PLANNING REPORT

PLANNING AND ZONING COMMISSION

NOVEMBER 6, 2008

**1. Waterford Commons Monterey Drive and West Bridge Street
08-092FDP Final Development Plan**

PROPOSED SITE PLAN

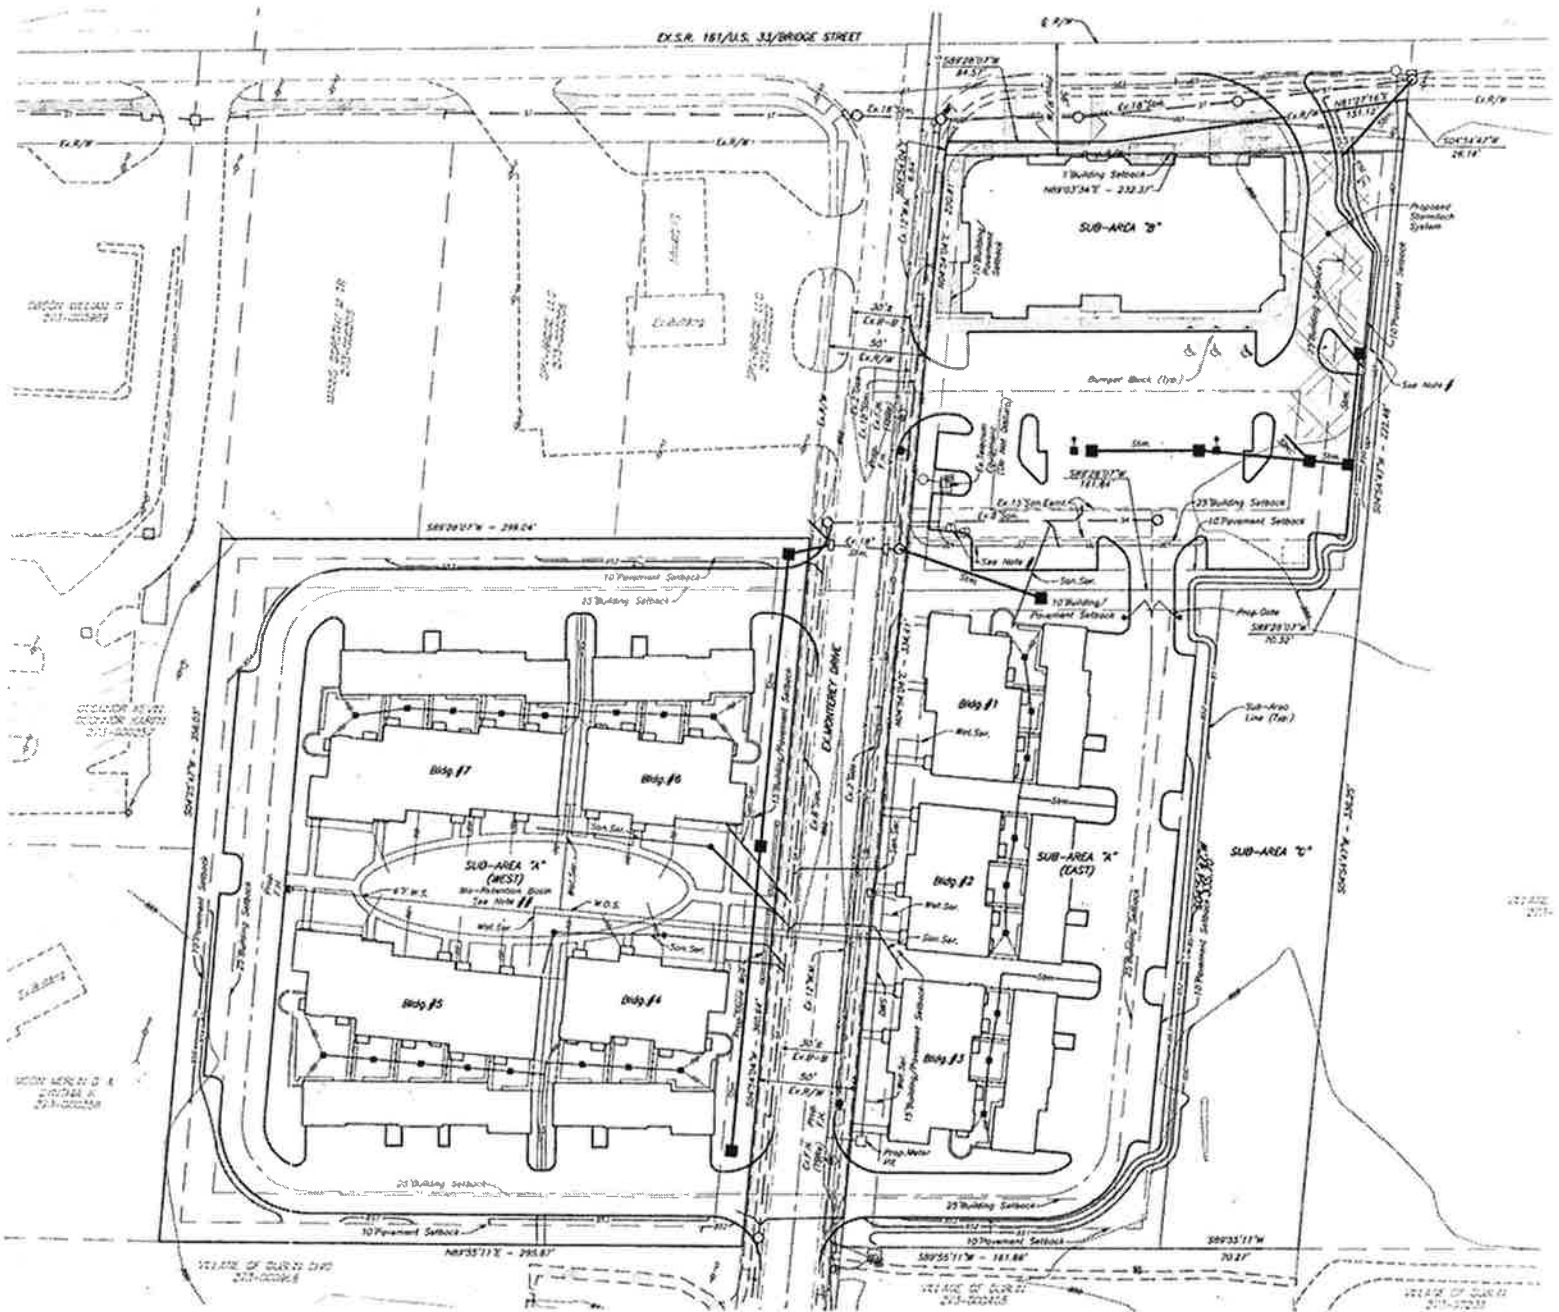
The proposed plans do not indicate any pedestrian connection from the front of the units to the garages and parallel parking spaces located in the private drive. A four-foot sidewalk needs to be provided from the front of the buildings between Buildings 1 and 2, and Buildings 2 and 3 (Condition 5).

- 4) The existing sidewalks will need to be repaired as part of this project;
- 5) A four-foot sidewalk needs to be provided from the front of the buildings between Buildings 1 and 2, and Buildings 2 and 3;

BUILDING 1

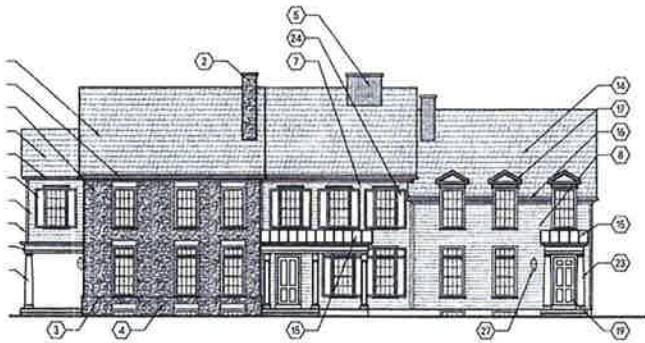
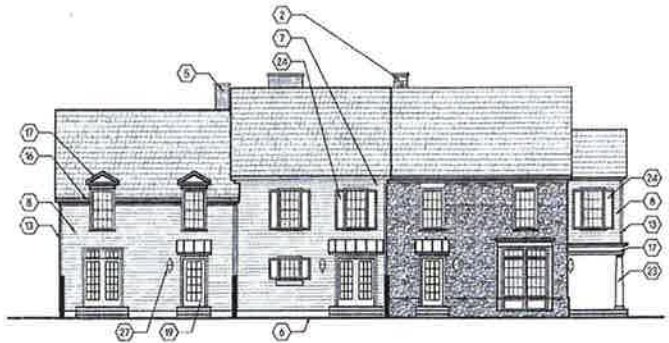
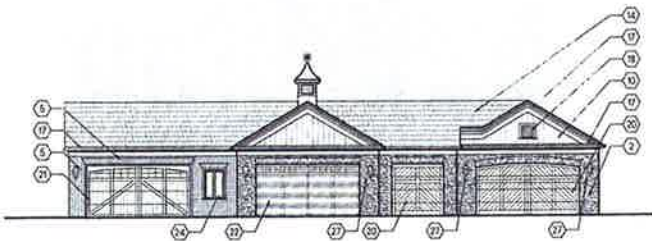
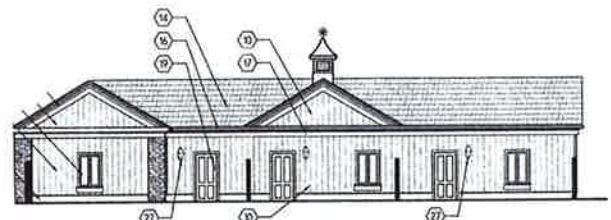
The applicant has provided the percentage of masonry and vinyl on the front and side façades for each residential building and garage, which indicates vinyl siding does not exceed 27 percent vinyl siding. The proposed front and side elevations for Buildings 2-7 also show adherence to these requirements, with the use of vinyl limited to one unit on the three-unit buildings and two units on the five-unit buildings. Building 1 indicates the use of vinyl siding on two of the three units, which appears to be a drafting error that will need to be switched to masonry in order to meet the text requirements.

The rear of the dwelling units and interior sides of each of building incorporate a greater proportion of vinyl siding with two units on the three-unit buildings and four units on the five-unit buildings using siding. The predominant vinyl style proposed along the rear elevations is vinyl lap siding. Planning recommends the use of the vinyl cedar shake style to provide added architectural interest, which would apply to the inside units on Buildings 1 and 3-7.

- 9) That the landscape comments provided within the report be addressed, prior to the issuance of a building permit; and
- 10) The appropriate revisions be made to the proposed architecture as outlined in this Report.
